Sherwood Tailings Reclamation Plan

Responses to NRC Comments

Prepared by Washington Department of Health
Environmental Health Programs
Division of Radiation Protection
Waste Management Section

July 2000

FIGURE 1
 TAILINGS COVER ELEVATIONS
 AS OF 10/5/98

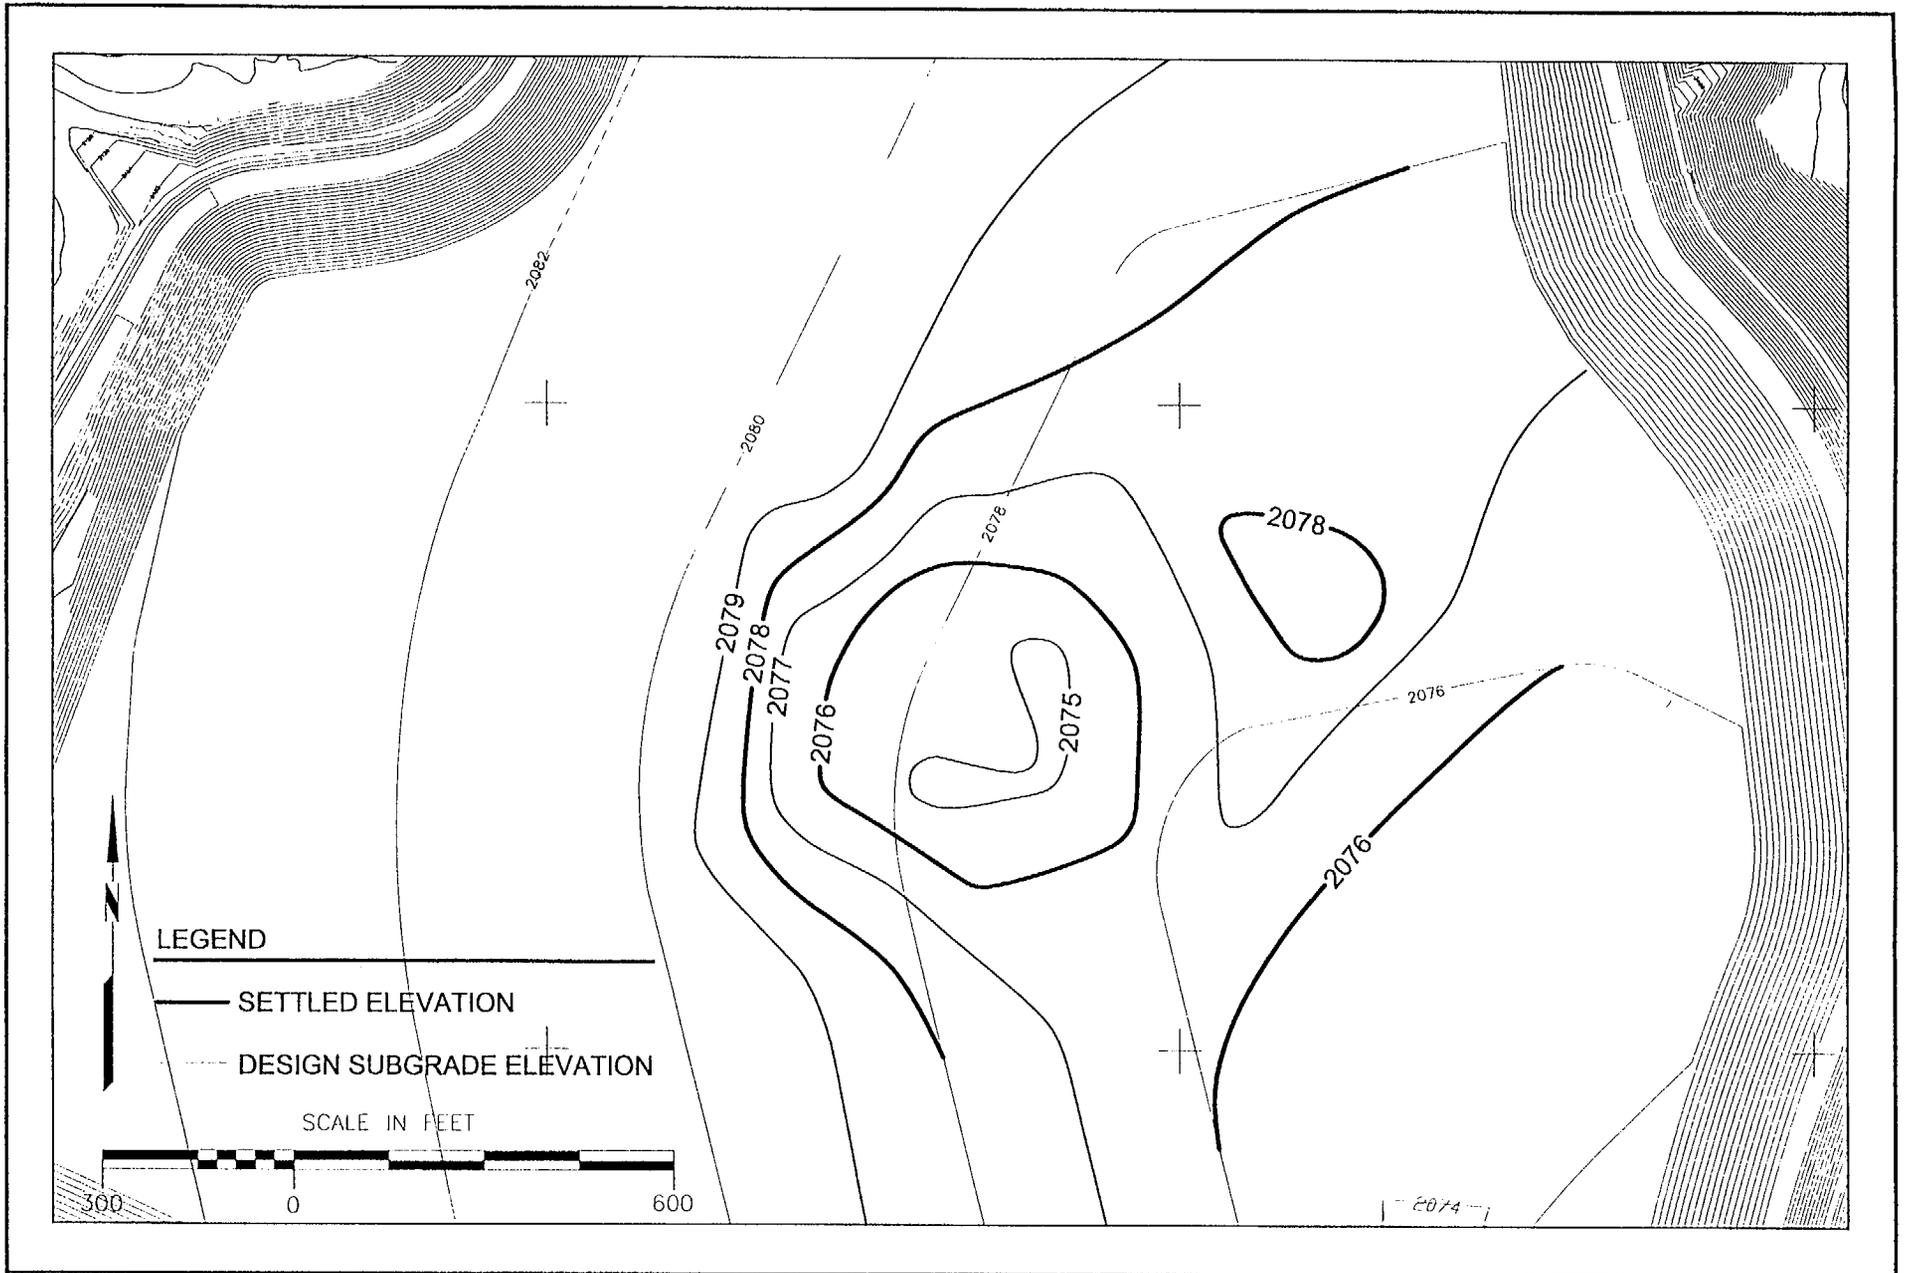
Survey results for areas around and within the settlement area were taken at the end of construction (9/95) and subsequently in 5/5/97 and 10/5/98. The results of the surveys are shown on Table 1. The 10/5/98 configuration is shown on Figure 1.

FIGURE 1
PREDICTED SCOUR ON
IMPOUNDMENT SURFACE

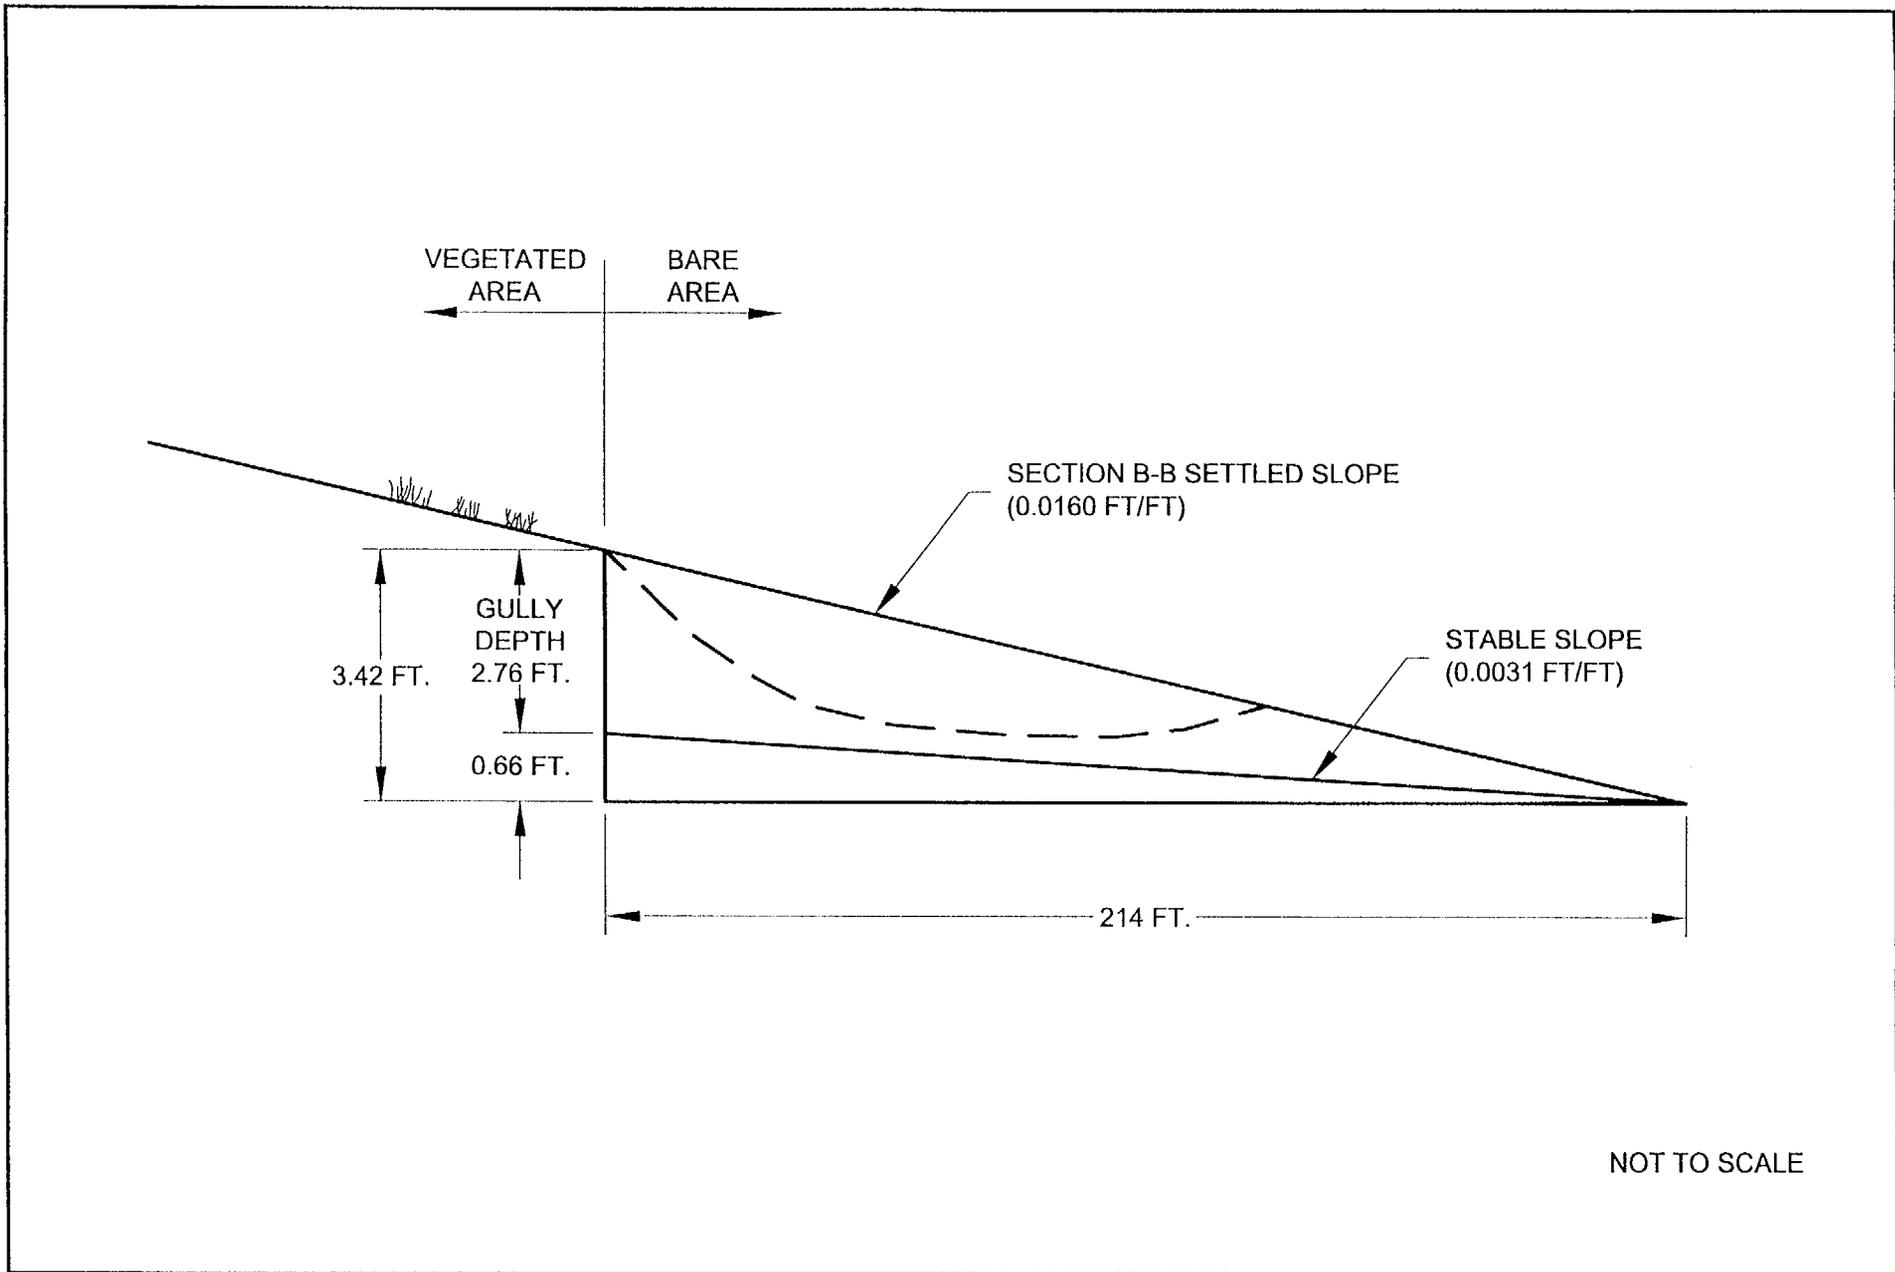
The stable and settled slopes are shown on Figure 1. The stable slope for the bare area was calculated to be 0.0031 ft/ft, which corresponds to a vertical drop of 0.66 feet for the 214-foot slope length. The slope of the impoundment surface for Section B-B was measured to be 0.0160 ft/ft, corresponding to a vertical drop of 3.42 feet. The amount of scour that could potentially occur during the PMF is 2.8 feet.

The analysis shows that under worse case assumptions, a gully approximately 3 feet deep could occur over the surface. This erosion will not however adversely impact the performance of the cover. First, since the cover is 13.6 feet thick (only 12.6 feet was required), removal of a small portion of the total thickness of the cover over a very small area would not cause any change to the overall radon flux from the cover. The area over which the erosion would occur would be so small as to be insignificant relative to the area of the rest of the reclaimed impoundment. In addition, the material removed from the erosion feature would be deposited over another portion of the cover. Therefore the total material covering the tailings would not change. Furthermore, the water content in this area will be greater than the water content assumed for the radon modeling (likely saturated in at least the lower portion of the cover which would eliminate all radon flux from the tailing). Therefore, the flux from this area and the overall average flux from the reclaimed tailing impoundment will be less than 20 pCi/m²/s requirement.

FIGURE 9
 FILTER REGION FOR 18" RIPRAP

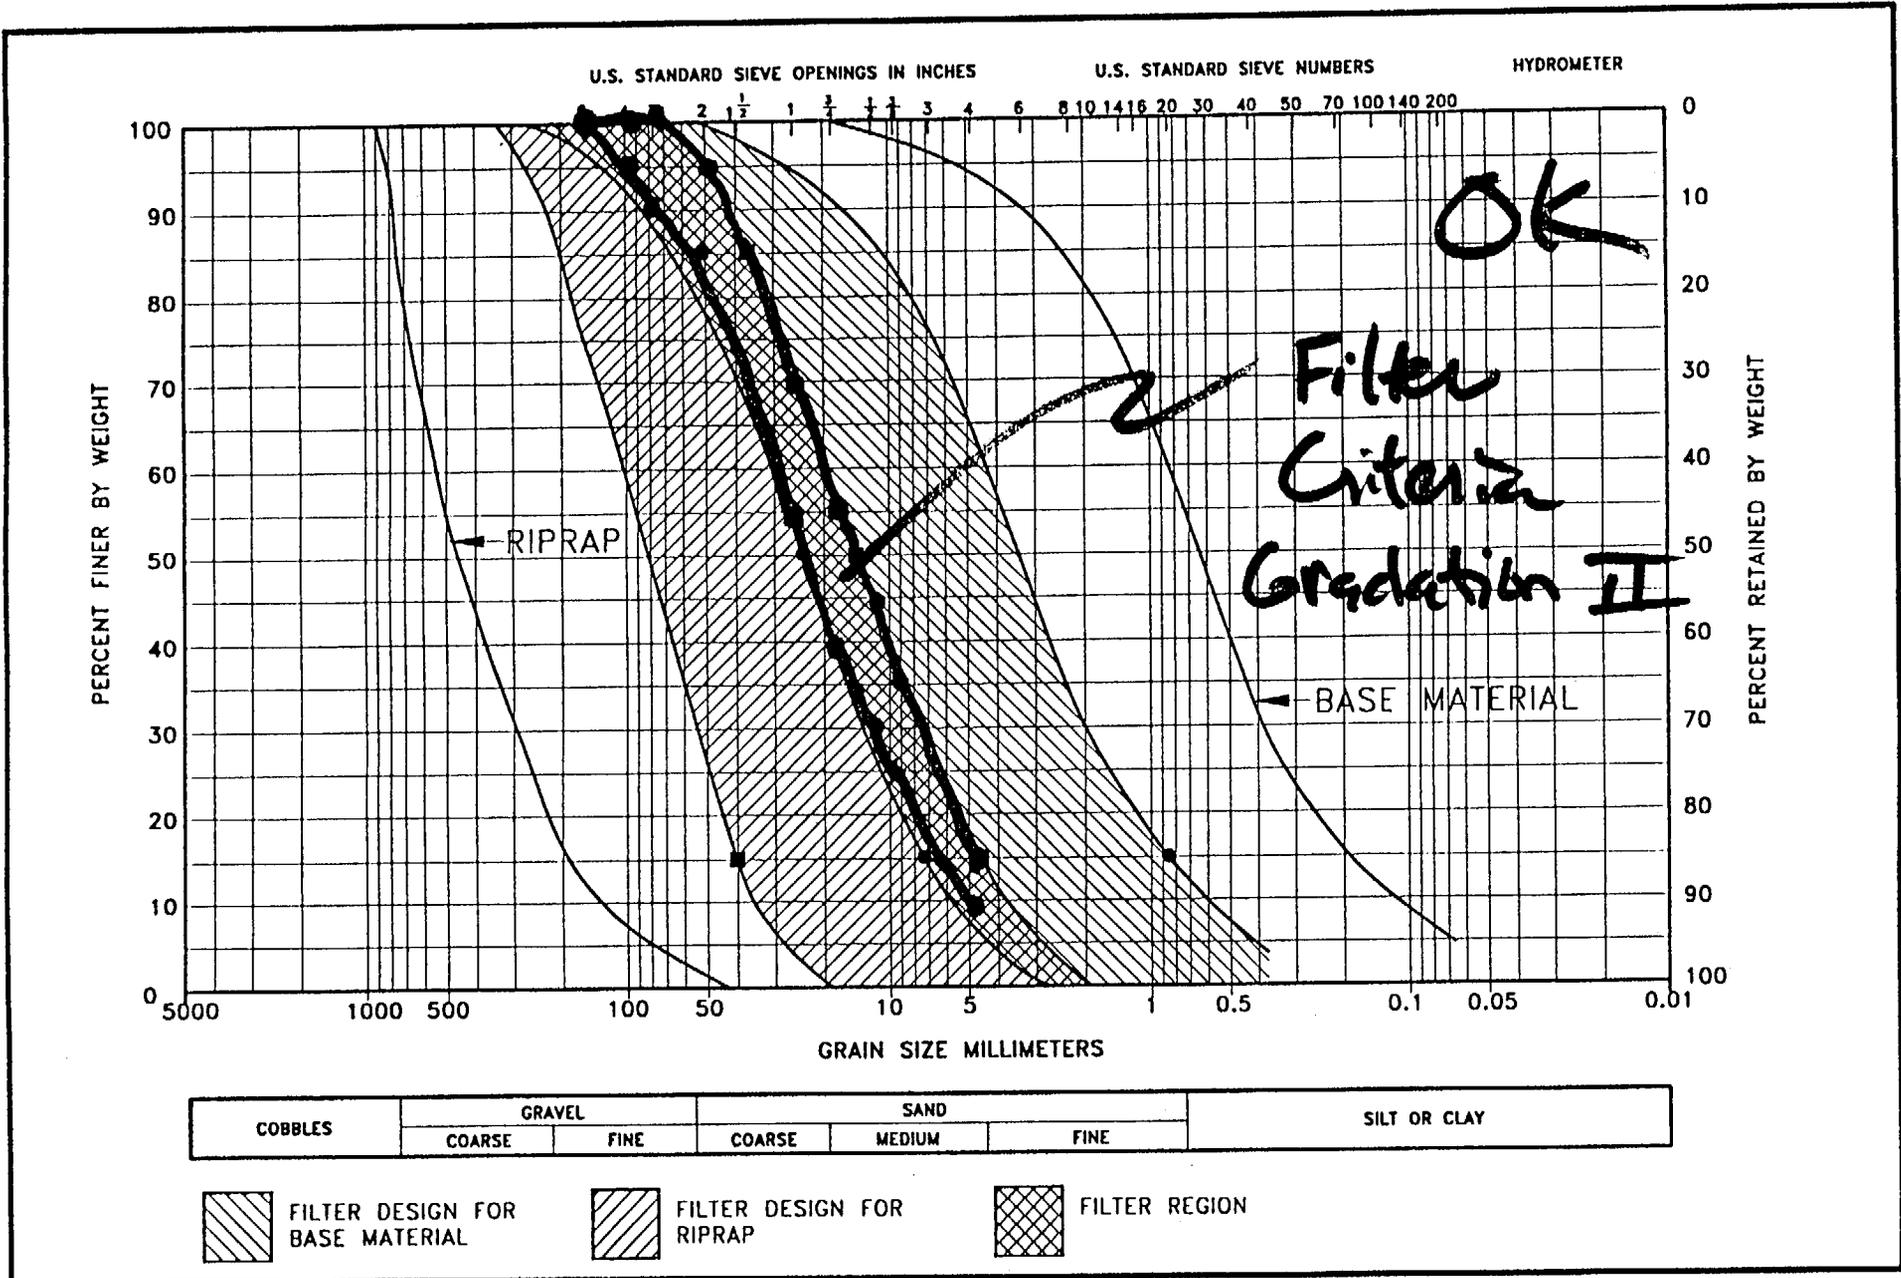
For greater D_{15} sizes on the bottom of the first sheet of Table 2A ~~the D_{85}/D_{15} ratio is D_{85}/D_{15} by the continuation sheet~~ considerably larger than what is called for in typical filter design criteria, i.e., sections 21+14 - 22+48 to 67+42 - 68+71.

Same problem occurs again in the lower portion of the continuation sheet for the embankment but no need to speak of here.

OK on Filter layer functioning to protect sand Subgrade assuming d_{85} of sand typically No 10 sieve

... Note in Table 3.2 suggest D_{85} is typically to or larger. The

FIGURE 6
REALIGNED DIVERSION CHANNEL LOCATION

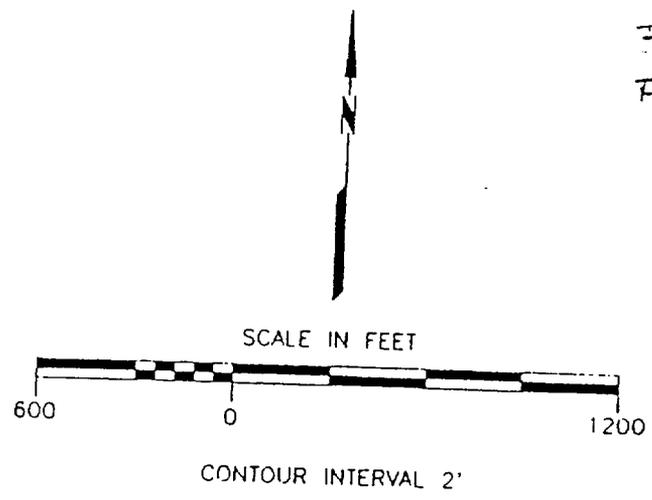
Diversion Channel Outfall Erosion Protection - If the diversion channel alignment is changed as shown in Figure 4 of the October 9, 1995 submittal then the consultant proposes to eliminate the erosion protection at the diversion channel outfall. The rationale for this is that although erosion will occur during large storm events, it is very unlikely that the erosion path will intercept the tailings impoundment.

The divergence will be defined by the angle Θ only if there are no topographic features that will confine the flow further. In looking at the topography downstream of the diversion channel outfall, there are a number of swales that would confine the flow and train it to a path even narrower than computed by the consultant. The attached figure shows the most likely flow path for diversion channel discharges based on the topography of the hillside below the channel outlet. This flow path remains a substantial distance away from the tailings cap.

FIGURE 1  
 LOCATION OF  
 NEEDED RIPRAP MODIFICATIONS

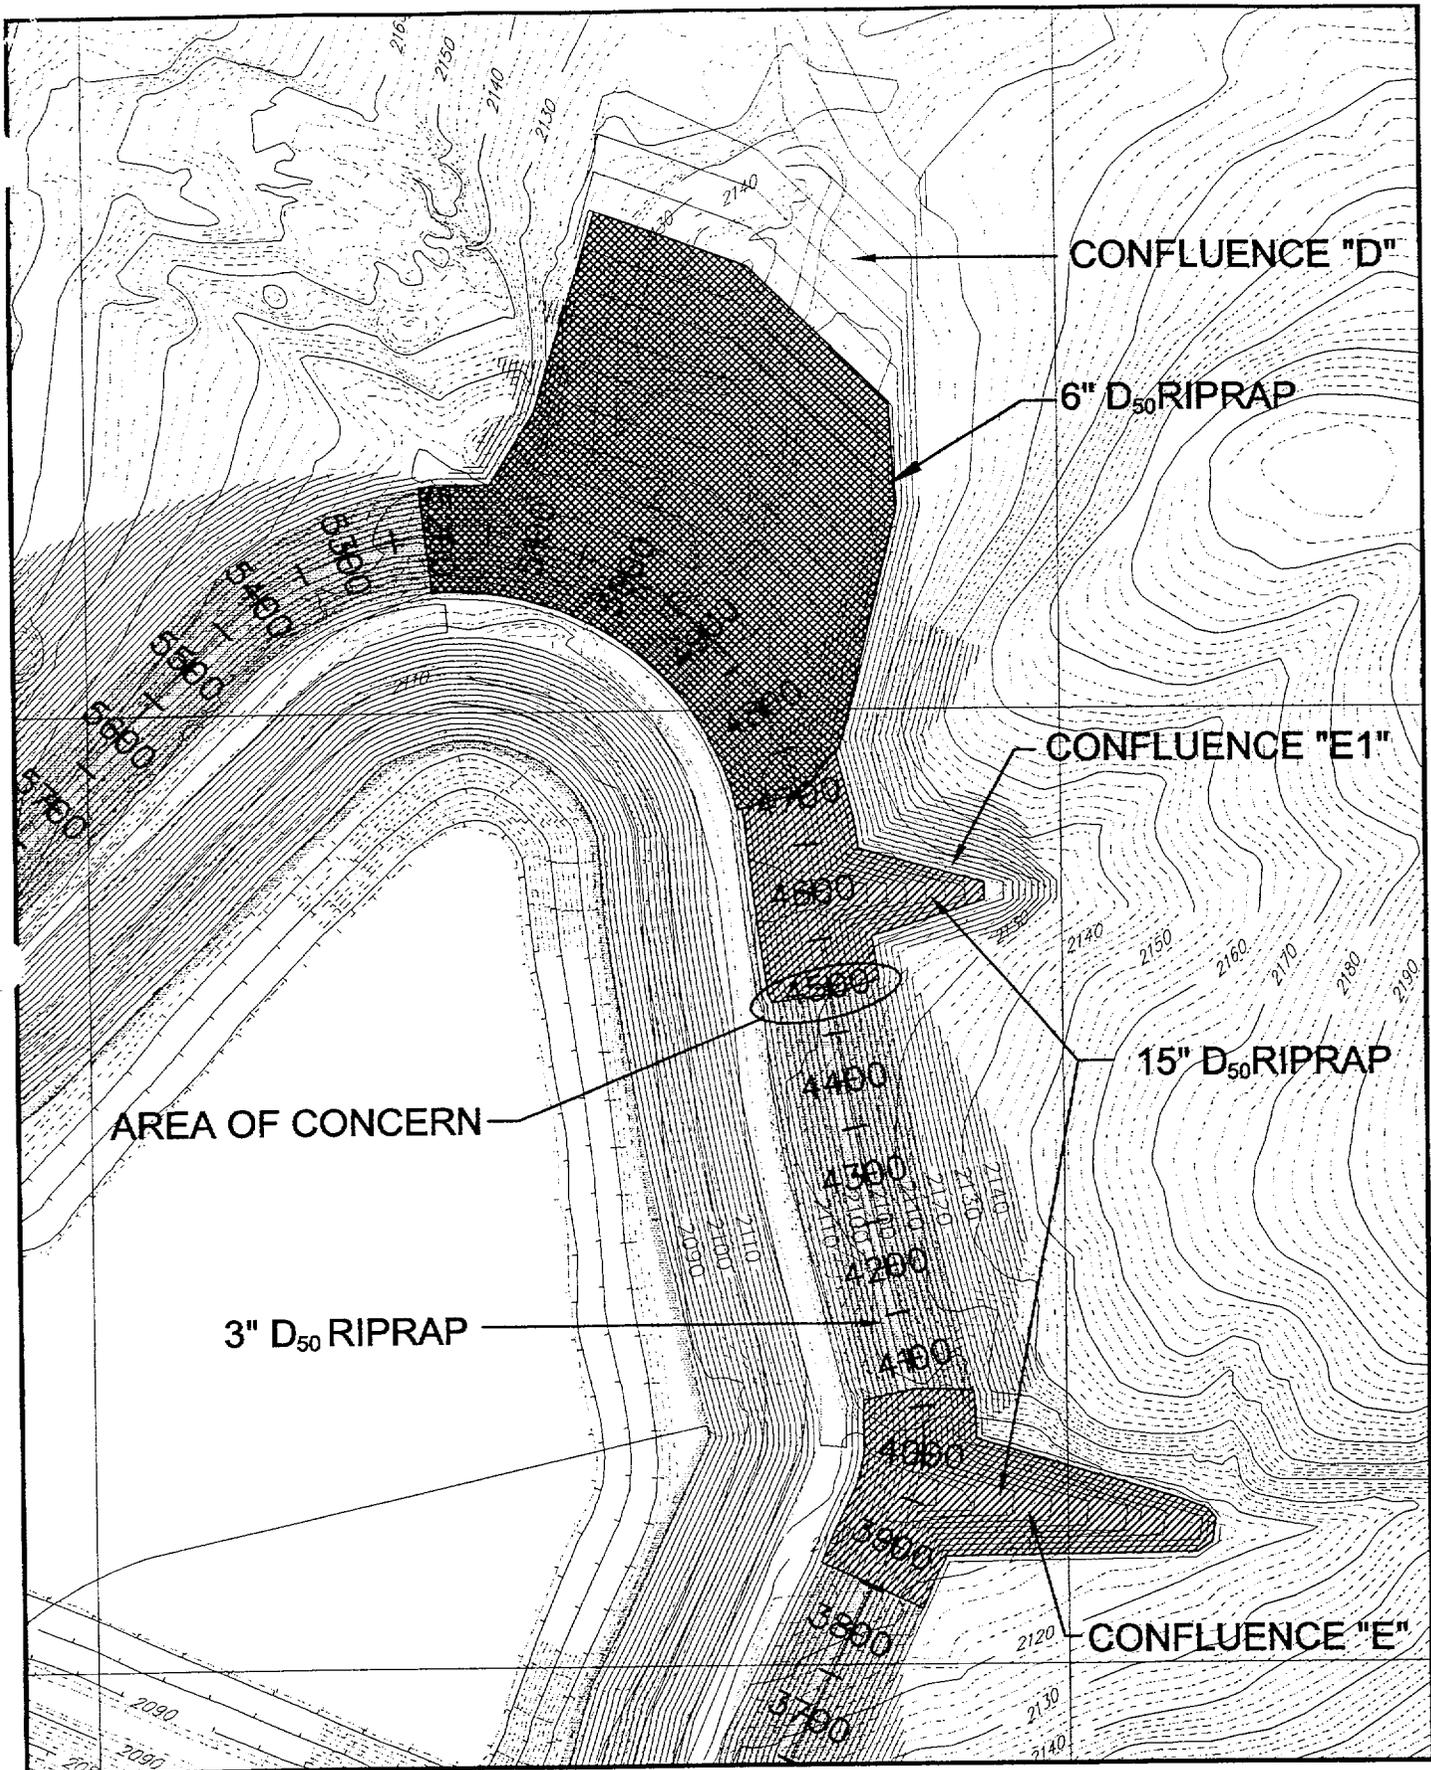
The area in question exists at the transition between confluence E1 and the diversion channel immediately south of the confluence. The general location is shown on Figure 1 (attached). At the transition from 15-inch riprap in the confluence to 3-inch riprap in the diversion channel, there is an abrupt elevation change, as the bottom elevation of the channel is approximately 3-4 inches lower than the elevation of the bottom of the confluence. This elevation difference appears to be a result of heavy construction activity which occurred over the 3-inch riprap in the diversion channel as the larger riprap was being placed in the confluence. This heavy construction activity appears to have pushed the 3-inch riprap into the underlying filter and foundation soil.
